CITY OF FREDERICKSBURG HISTORIC REVIEW BOARD

TUESDAY, JUNE 15, 2021

7. CERTIFICATE OF APPROPRIATENESS APPLICATIONS

Application Number: 21-60
Date: June 15, 2021
Address: 720 W San Antonio
Zoning: R1
Owner: Creath
Applicant: Shayna Thompson
Rating: Low
Proposed Modifications: addition

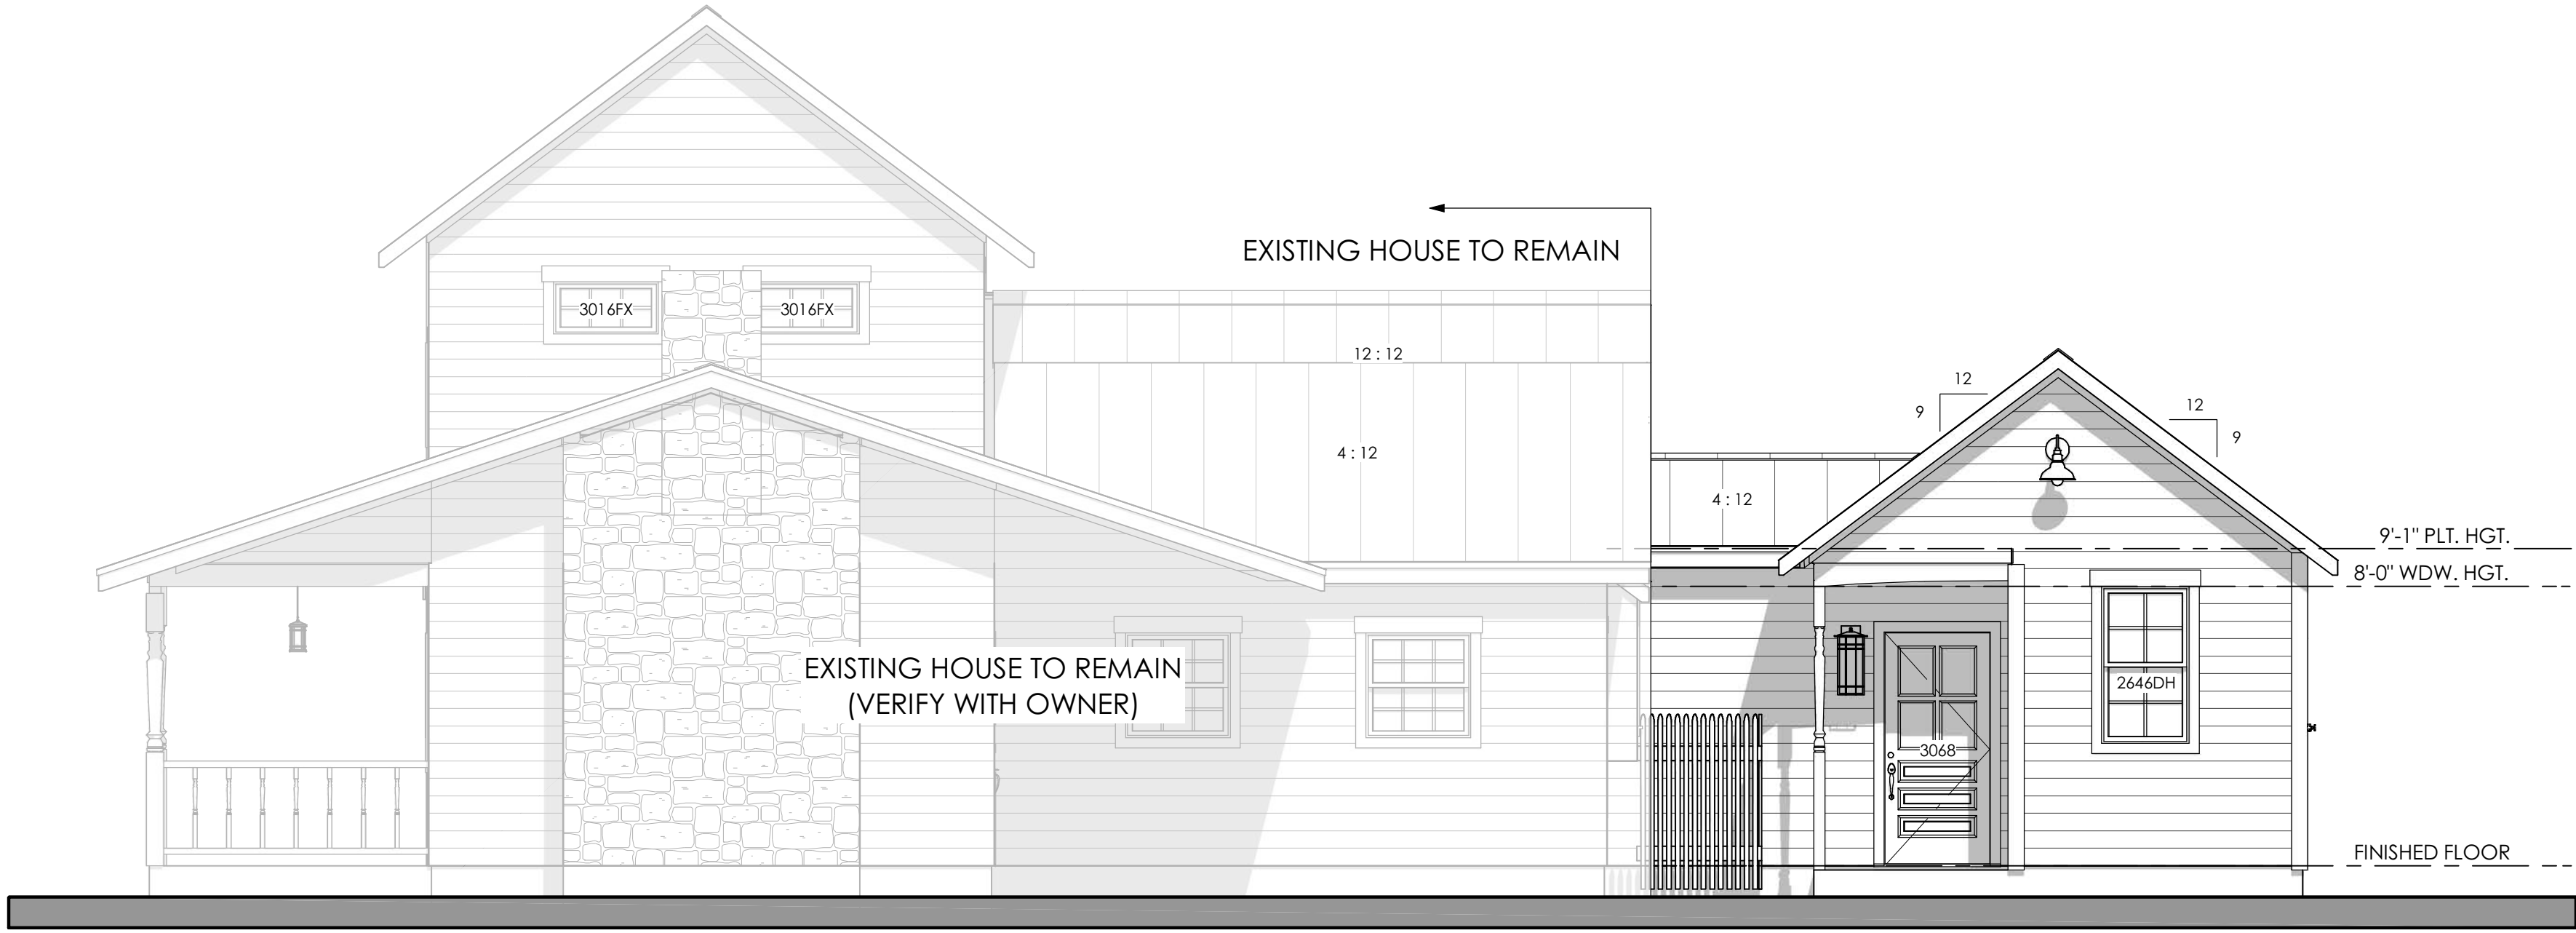
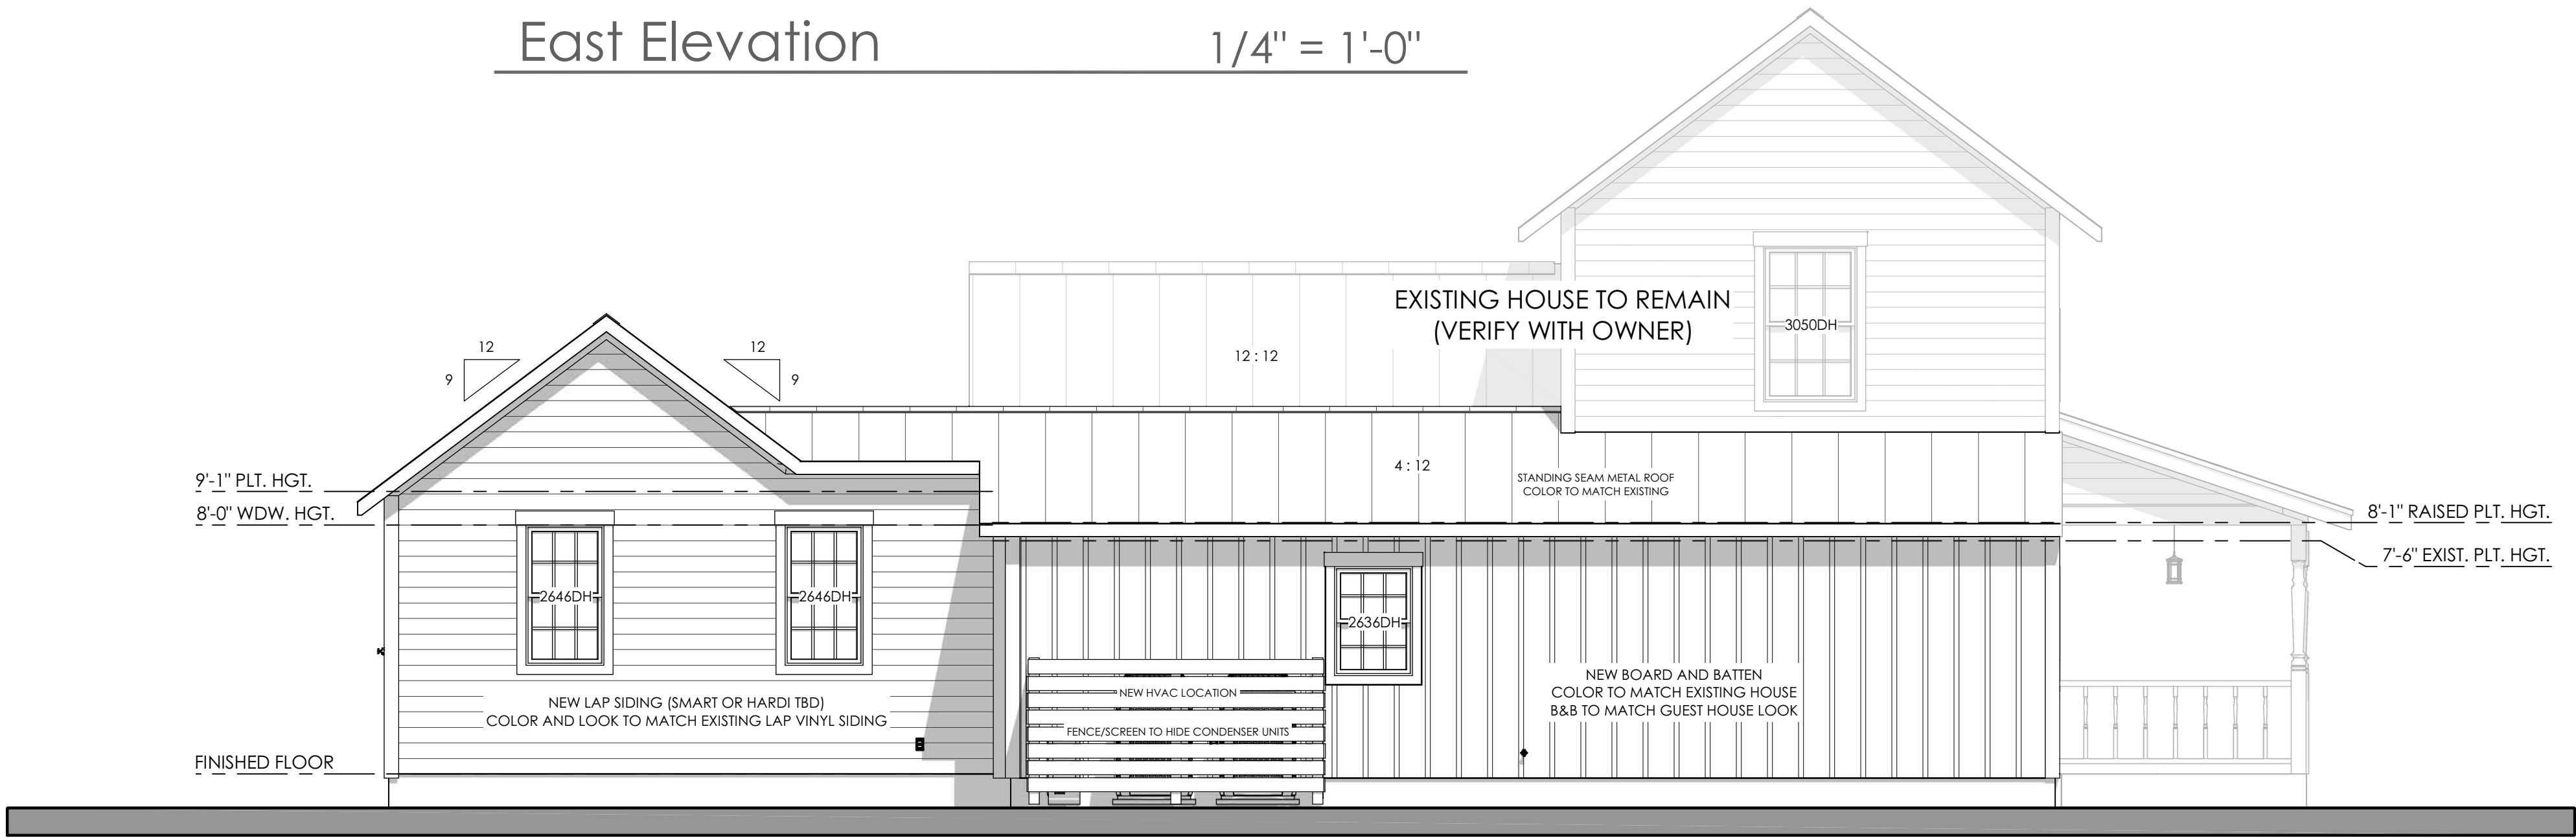
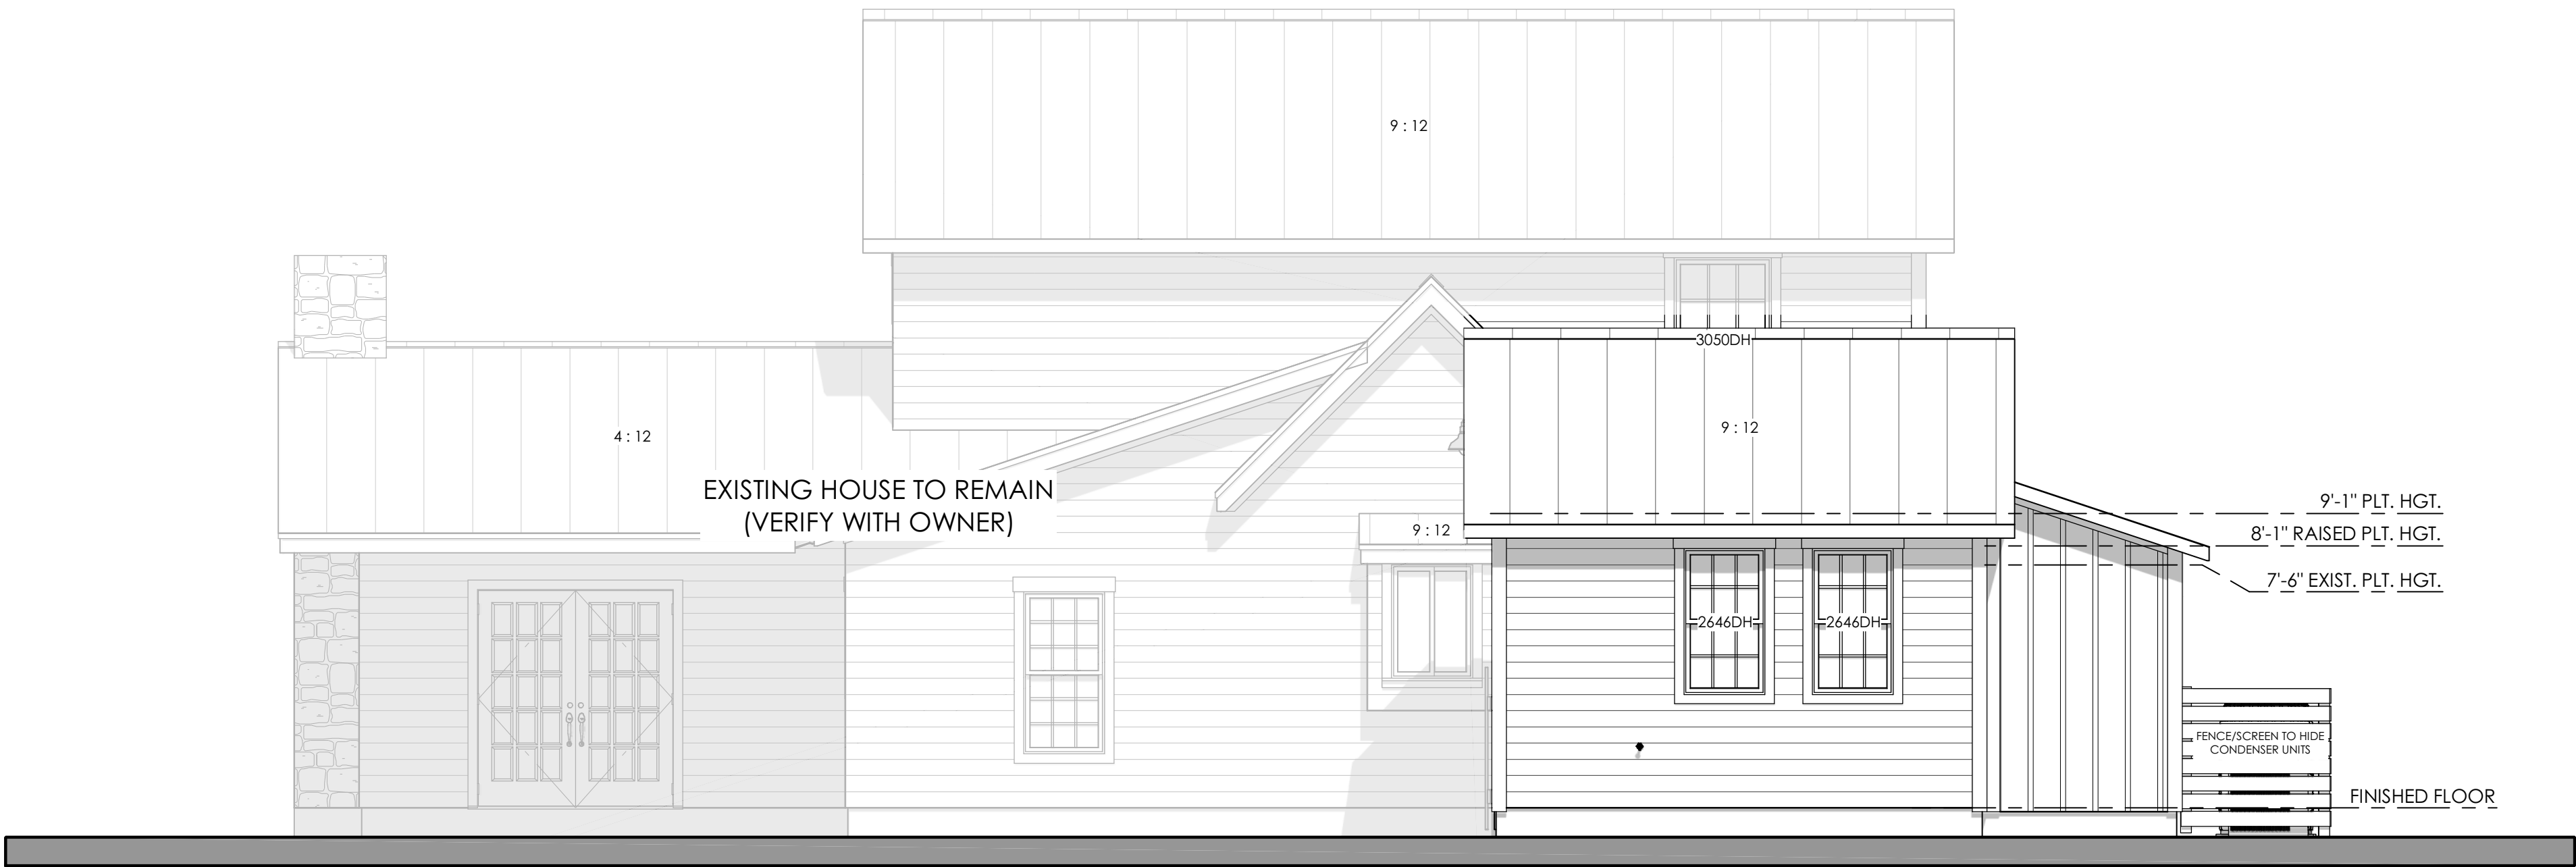
1. build an addition attached to an existing 1960's addition with lap siding and
2. add pitch to the existing flat roof of the 1960's addition

The original structure has had original features removed and numerous additions added over time reducing a historic aged structure to a low rated house. The proposed addition and roof pitch change will not negatively impact the historic district. Staff recommends approval as presented.
